## **RESPONSE TO FCC CORROSEPONDENCE REFERENCE NO. 32032**

Re: FCC ID LO6-DVRSUHF

Applicant: Futurecom Systems Group Inc Correspondence Reference

LO6-DVRSUHF 380-512 1-20

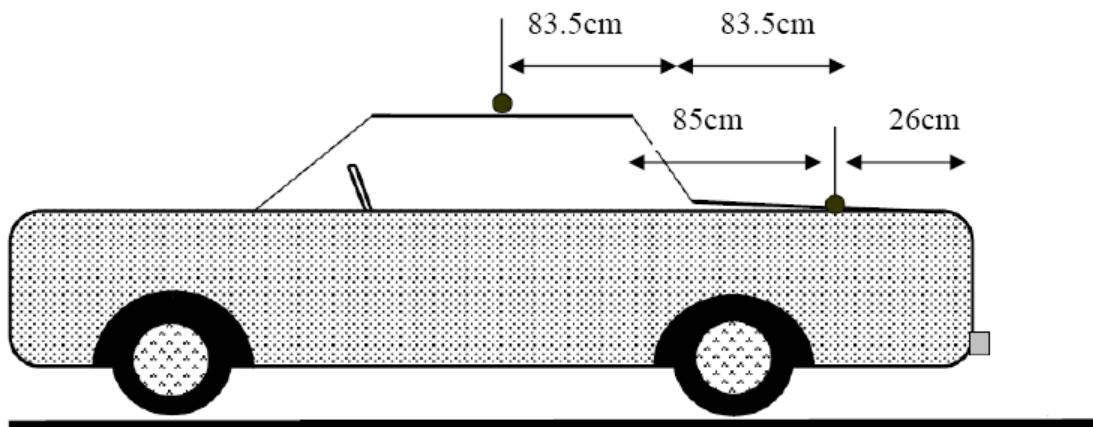
10) Figure in Appendix A shows 83.5 cm from roof edge to trunk antenna; SAR part says trunk antenna is 26 cm from end of trunk - please explain how antenna to trunk edge distance is same as in MPE test, or explain Why if different.

Additionally, response 10 below includes a side view illustration of an automobile with 83.5cm and 85cm distances.

The illustration in Appendix A is a top view of by-stander positions (1-5) which includes lateral distances from the car body along with roof and trunk mount antenna locations. The front and rear windshields are not included in the illustration and therefore the roof edge to the trunk is not practical. The sole purpose of the 83.5cm was to demonstrate that by-stander 2 is positioned at an equal distance between the roof and trunk mounted antennas (refer to note 2 in Appendix A). The rear window is partially included in the 83.5cm distance. The 26cm distance is from the trunk mount antenna to the trunk edge towards the rear of the automobile. Refer to figure below.
